BAR Meeting
November 11, 2015

ISSUE: Permit to Demolish/Capsulate and Certificate of Appropriateness for an Addition and Alterations

LOCATION: 211 North West Street

BAR2015-00164 & BAR2015-00165

STREETSIDE VIEW B

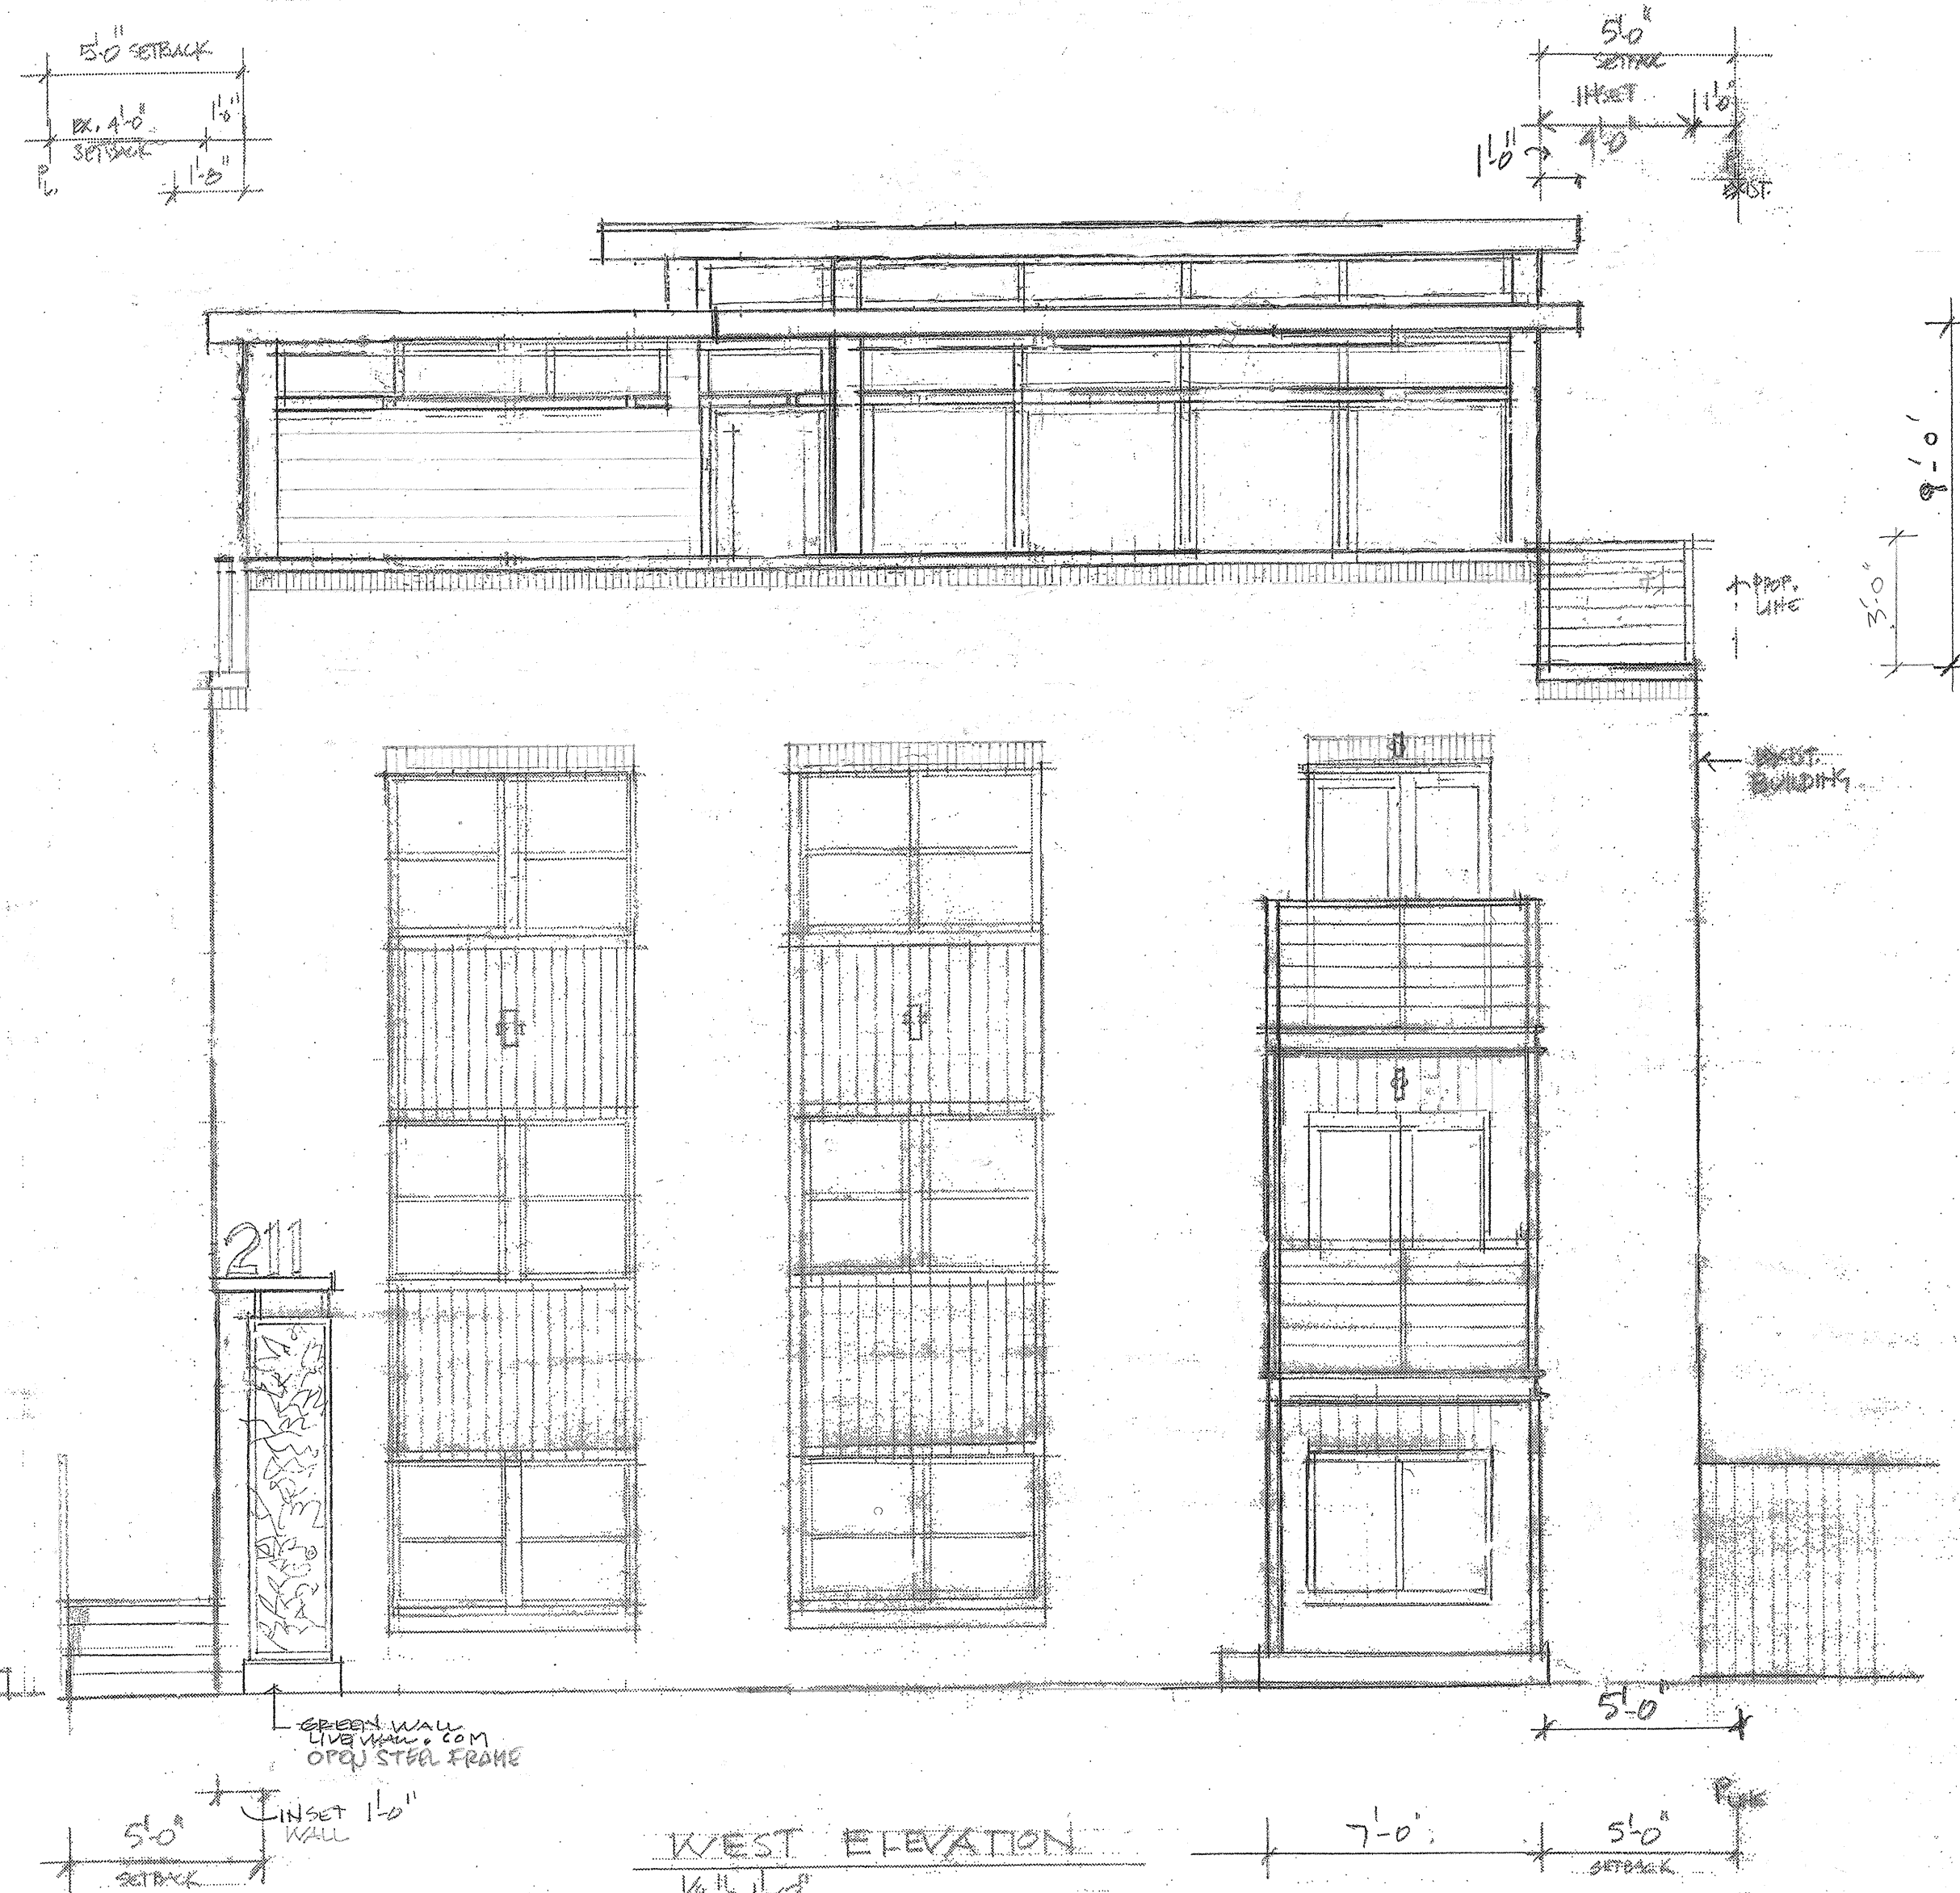
One area previously identified by the BAR as problematic was the placement and height of the rooftop addition. Several BAR members noted concern with the design and its overall visual bulk. The applicant's response in this current submission is to make the addition a more integral part of the building by reducing its apparent height as viewed from the street by two feet, changing the roof structure from a shed to a flat roof and recessing the addition fifteen feet back from the front building wall. These details significantly improve the integration of the rooftop addition with the rest of the building.

* REDESIGN PUSHES NEW TOP FLOOR
 ADDITION TO THE REAR OF THE
 BUILDING TO MINIMIZE VISUAL
 IMPACT TO EXIST. STRUCTURES
 ON WEST STREET.

REVISED SKETCH

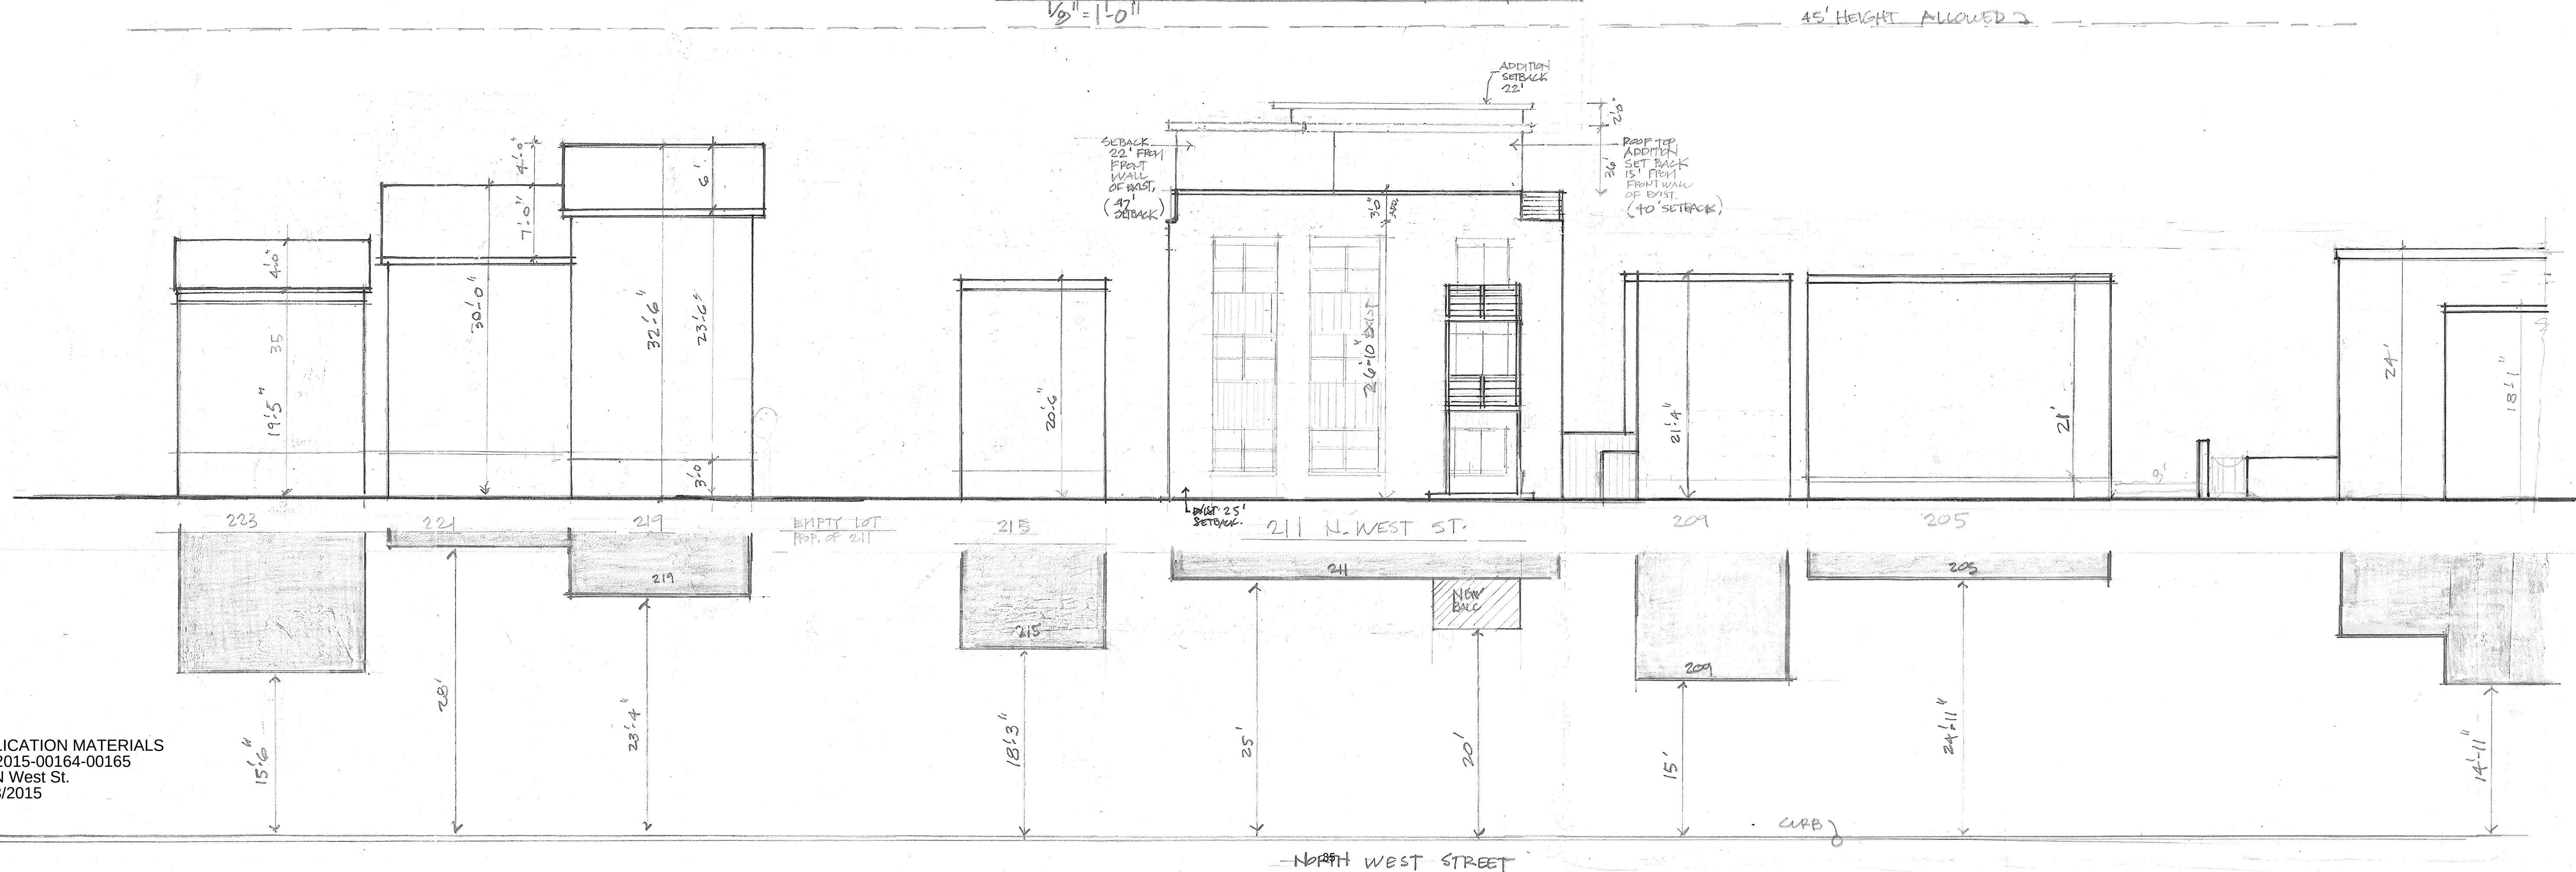
- There appear to be several encroachments into the required 5' north and south side yard setbacks that do not comply with zoning:
 - Front and rear decks/balconies
 - 4th floor overhang
 - Applied architectural feature on the north elevation

1. UPPER ROOF 1'-0" OVERHANG - ON NORTH & SOUTH EAV.
2. FRONT BALCONY MEET 5'-0" SIDE YARD SETBACK
3. SOUTH WALL ADDITION MEETS 5'-0" SETBACK
4. NORTH WALL ADDITION MEETS 5'-0" SETBACK
5. FRONT NUMBERS - MOUNTED TO WEST WALL PROJECTION - GREEN WALL
